Argosy Drive

External Lighting Strategy Addendum

Columbia Threadneedle Investments Ltd

Figure 2 –Revised Argosy Drive scheme

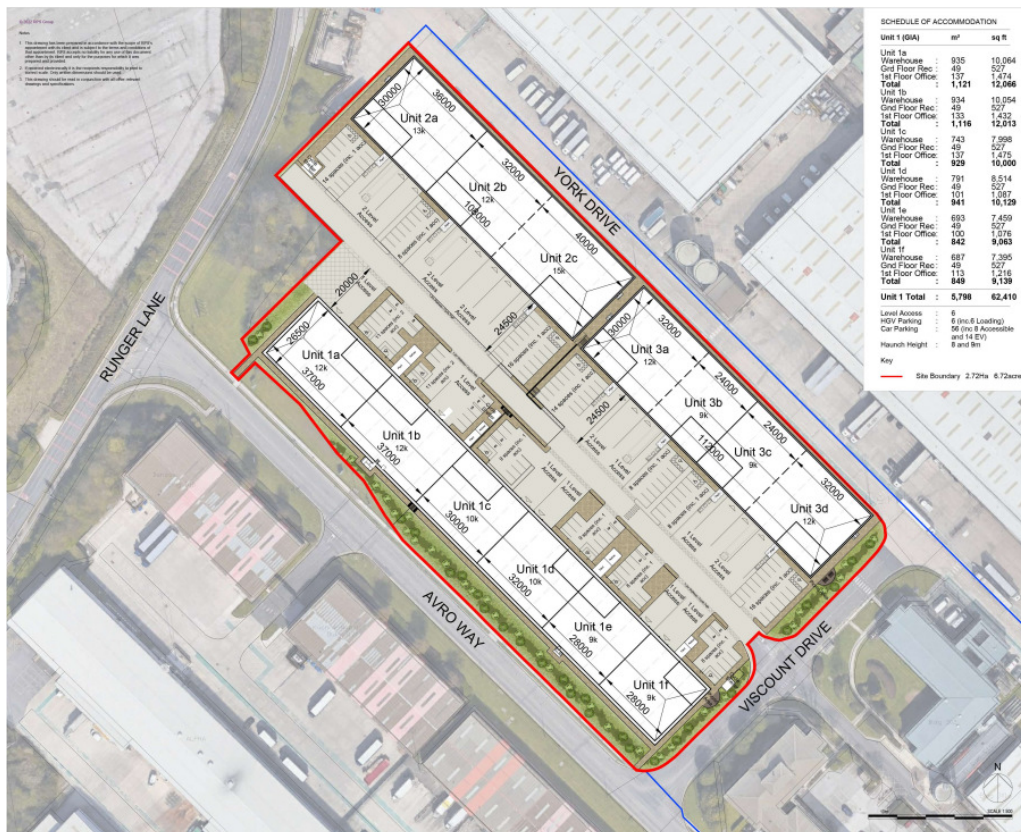
Following market testing and a period of value engineering Columbia Threadneedle Investments have decided to reduce the number of Units in the Unit 1 terrace from 8 to 6 whilst maintaining the overall footprint of the Unit. Units 2 + 3 remain the same. The new masterplan is presented in Figure 2 below:

The design changes of the redevelopment of Argosy Drive require the lighting to be adjusted to suit the new phasing of the scheme. The initial phase of the construction of Unit 1 is still to be constructed, Units 2 & 3 will follow at a future stage rather than as one scheme. The first building to be constructed, unit 1, has also been altered from 8No. terrace units to 6No. terrace units to provide units with a larger usable space while maintaining the same overall building footprint.
